# SERVICE BULLETIN

## MANDATORY ACTION REQUIRED

**Subject:** Chafing of Aileron Cable Assembly P/N 7227151-522WE.

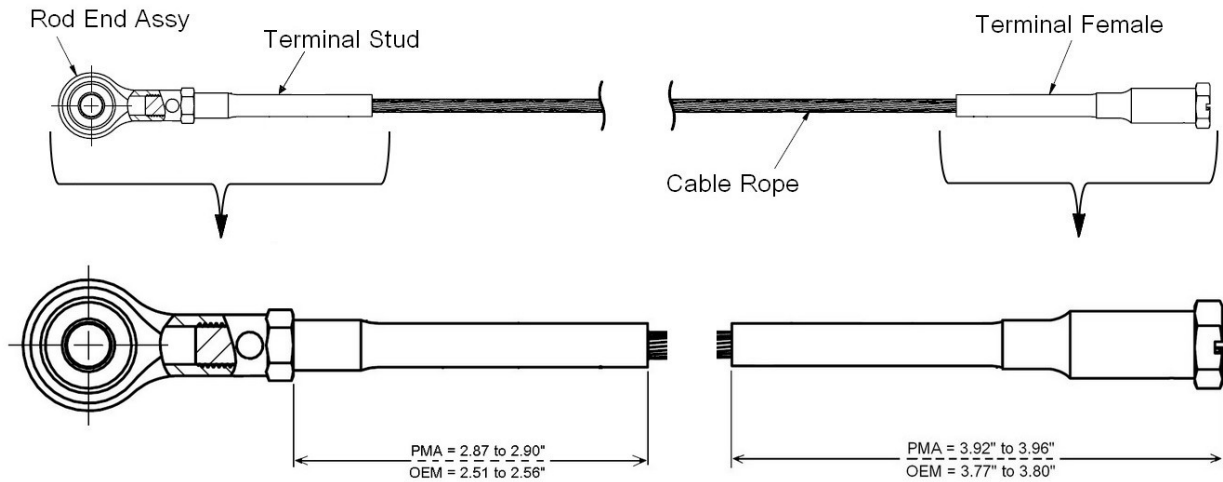
A SAAB 340 operator has reported instances of chafing wear damage on Wencor PMA aileron cables P/N 722151-522WE. The wear was observed during a line maintenance inspection. Upon subsequent inspections, the operator reported finding several more instances of chafing wear damage in their fleet, for a total of five (5) cables exhibiting signs of chafing wear damage. In all instances, the wear affected cables were installed in the forward outboard position at locations where the cables pass through the fairleads as shown below.

Chafing wear damage is dependent upon the installed location of the aileron cables. If the cable passes through a fairlead as in the case of the forward aileron cable run, chafing wear is possible. However, the aft aileron cable run does not pass through any structure, therefore cables installed in this location may not experience chafing damage.

Chafing wear damage has been observed on the outer strands of the 19-strand cables where they pass through the fairleads. Since the forward aileron cables pass through fairleads, those cables may be subject to chafing wear damage. Of the forward aileron cables on each wing, the outboard cables may experience greater vibration and would typically be the one contacting the fairleads and experiencing wear. If chafing wear damage proceeds to the point of cable failure, corresponding aileron control would be lost in the direction controlled by the failed cable. The opposite control direction of that aileron would remain unaffected, as would both control directions of the aileron on the other wing.

Within the compliance time limits of section 3c, remove all Wencor aileron cable assemblies PN 722151-522WE that have chafing wear damage that exceed the limits defined in the SAAB 340 AMM 27-00-00-06. Send the removed cables to Wencor. Do not replace removed aileron cable assemblies with a Wencor PMA aileron cable assembly.

At the operator's discretion, any serviceable Wencor PMA aileron cable assemblies that are found within the wear limits of the SAAB 340 AMM 27-00-00-06 may be repositioned from the forward aileron cable run to the rear aileron cable run that does not pass through any fairleads. Service experience has shown that cables in this location may exhibit reduced chafing wear.
